MIL-M-38510/377(USAF)
AMENDMENT 2
18 June 1992
SUPERSEDING
AMENDMENT 1
9 November 1984

MICROCIRCUITS, DIGITAL, ADVANCED LOW-POWER SCHOTTKY TTL, DECODERS, MONOLITHIC SILICON

Device type 01
Case 2

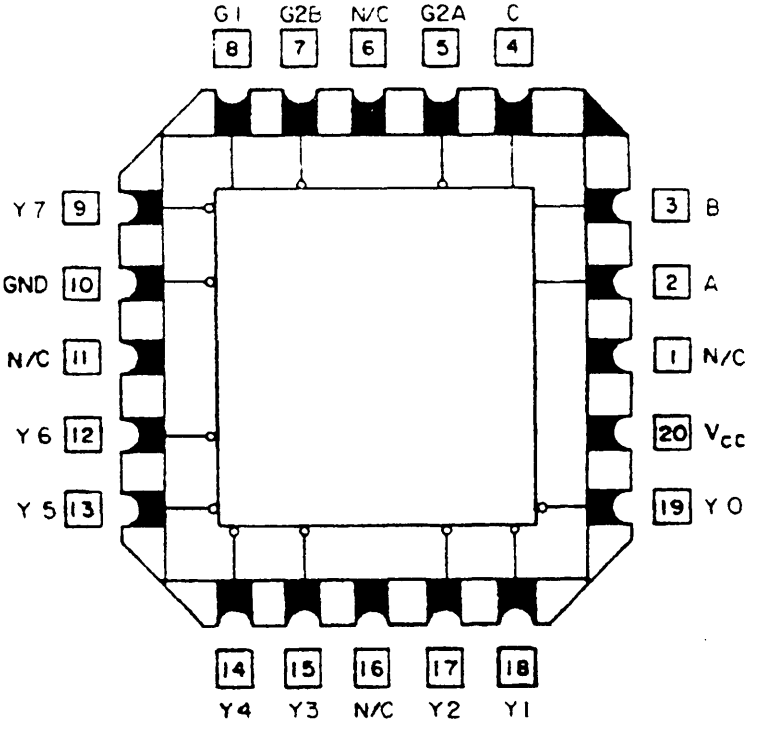
FIGURE 1, Device type 01, Case X: Delete "Case X" and substitute "Case 2".

FIGURE 1, Device type 01, Case 2, delete and substitute the following:

FIGURE 2. Logic diagram and truth table.

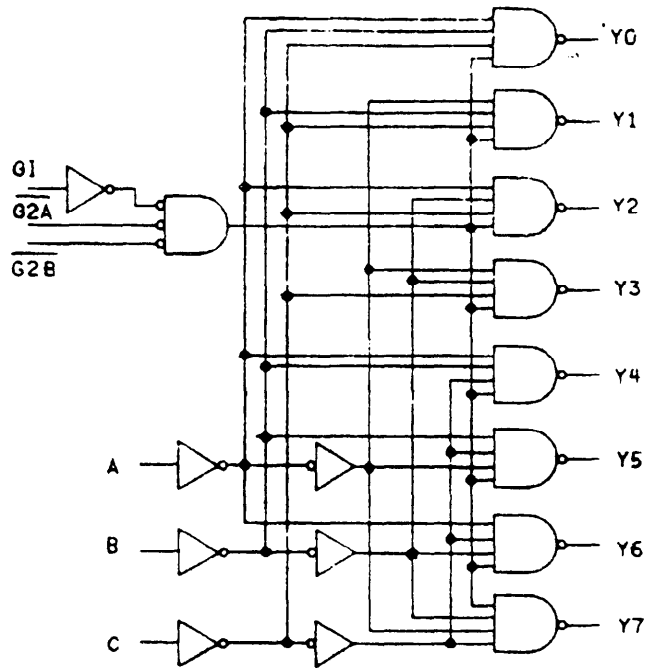
FIGURE 2: Delete and substitute new figure 2 as printed on page 4 of this amendment.
